Attachment 2 – Council's Out of Sequence Assessment Checklist

ATTACHMENT 2 - PRCUTS IMPLEMENTATION PLAN OUT OF SEQUENCE COMPLIANCE TABLE

Image 4 - Extract from proponent's urban design scheme indicating the proposed building envelope

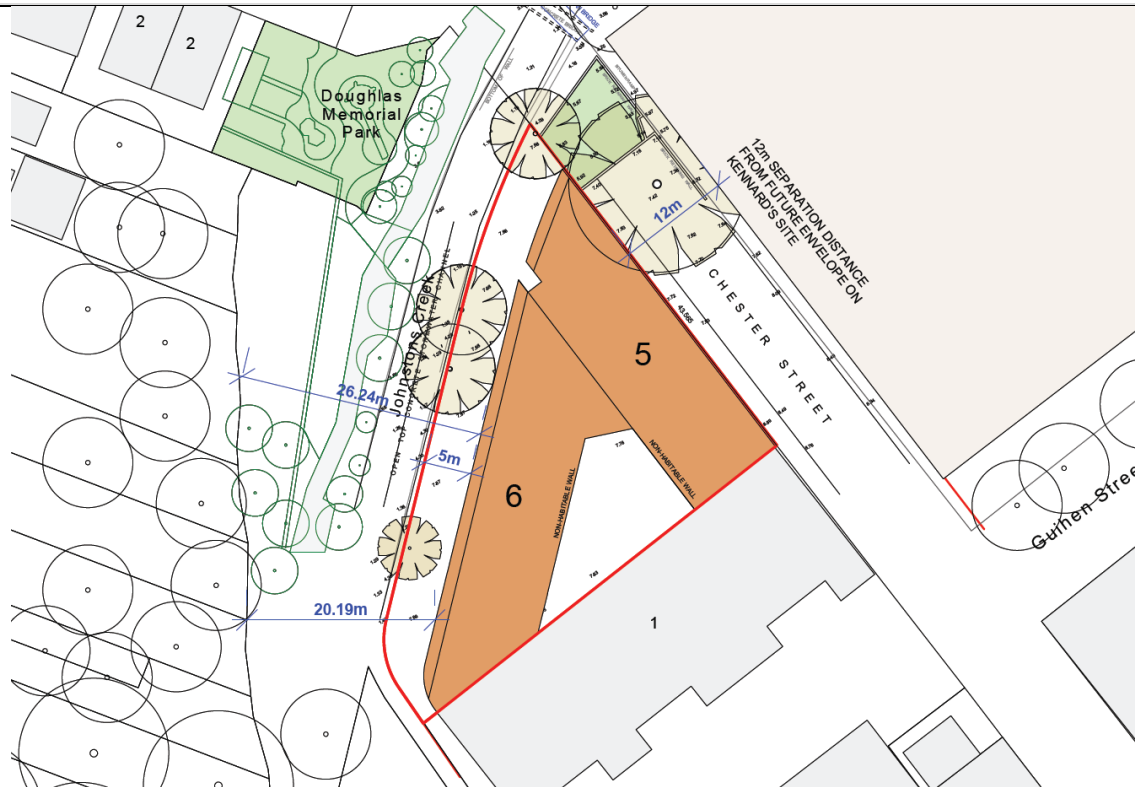
2. *Preserve the predominant zero lot setbacks to reflect the existing warehouse character* - The proposed design only partially 'preserves' the zero lot setback, however the existing building on this site and adjoining properties do not have complete zero setbacks. The site is occupied by a two storey industrial building which is partially built to the site boundary with the remainder (to the north) used as a car park and hard standing terminating above the site's boundary with Johnstons Creek (refer to the image below). The proponent's design would result in a 5 storey residential development with a 37m frontage along Chester Street with no ground level or upper level setbacks and 7 storey development with 57m frontage with 5m setback along Johnstons Creek site boundary. It can be argued that the site, therefore, does not preserve its existing warehouse character. The proposed development would establish a new precedent for the character of the area of relatively bulky residential blocks with no street level or upper level setbacks.

In principle, the proponent's intention to retain the existing industrial character is supported, however, the proposed design scheme does not appropriately reflect the existing or desired character and therefore, should not be supported.

3. *Preserve the green pocket parks at the termination of Johnstons Creek Stormwater Channel No 55* - There is an existing pocket park at the end of Chester Street. The proposed triangular layout of the building results in hard edges/ poorly splayed corners at the interface between the existing park and the proposed building which is partially due to the irregular shape of the site (Refer to the image below). There is an opportunity to remodel the building layout by providing increased setbacks and deep soil planting at the northern interface which could soften the visual impact and enhance the amenity of the existing pocket park. The proponent's design does little to preserve/ enhance the green pocket park and is inconsistent with this objective.

Image 5 - Open space and Active transport map. Map anomaly highlighted in black box.

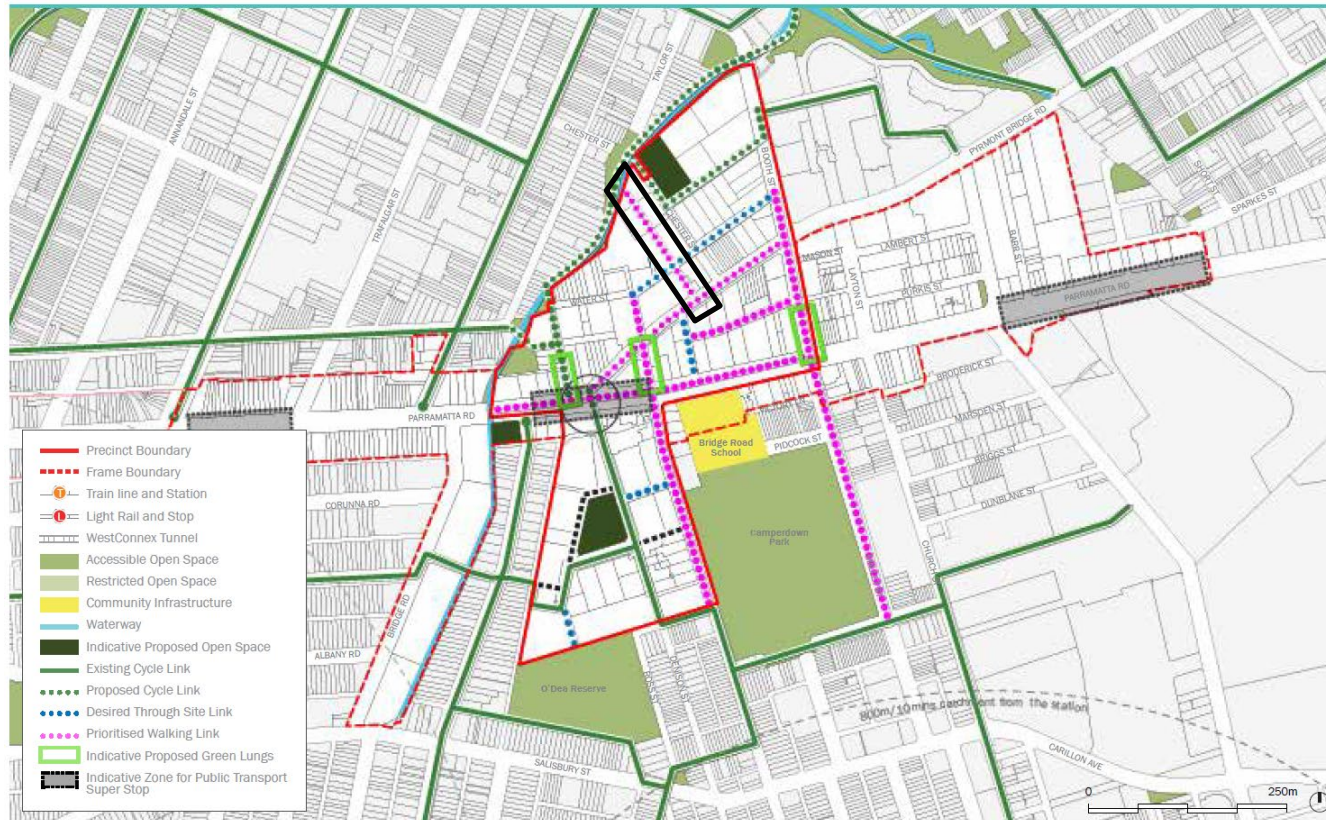
- *Implement the Sydney CBD to Parramatta Strategic Transport Plan:* The proposed Camperdown Open Space and Transport Plan (as shown in the image below) identifies a new Prioritised Walking Link between Johnstons Creek and Pymont Bridge Road through the subject site and adjoining sites. This is considered to be an anomaly in the map as the supporting text in the Precinct Transport Plan identifies 'Johnston's Creek to Pymont Bridge Road along Chester Street' (p. 177) as a Prioritised walking link where high pedestrian activity would be located.

For Chester Street to function as a successful prioritised walking link, public domain improvement works such as footpath widenings, new streetscape plantings to enhance Chester Street's amenity and streetscape are desirable. The Planning Proposal is inadequate in this regard as it does not contribute to making Chester Street as a vibrant street.

Furthermore, the Strategy identifies Johnstons Creek corridor from Booth Street to Parramatta Road as a future Strategic Cycle Link and this has not been adequately addressed in this Proposal.
